Access Compliance Report

Public Rights-of-Way

(Curb Ramps)

Intersection ID: 46183	Main Street: SWEETSPIRE_RD	Cross Street: NEEDLEPOINT_RD	Location: NW
ADA ID: E5C97F5E26A1	Ramp Type: PerpDiag	Initial Pass/Fail: Pass	Overall Compliance: No
Severity Score: 0			
Codes/Mitigation Info/Possible Solution		Field Measurements/Component Compliance

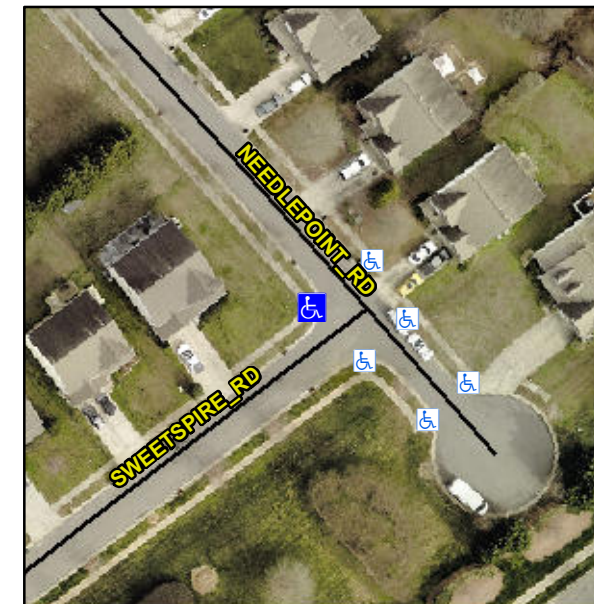
Remove & Replace Curb Ramp With Two New Directional Ramps or Equivalent. Remove & Replace Gutter.

Not Found, R304.2.1, R304.2.2-Perp, R304.3.2-Para, R305.2, R304.5.3
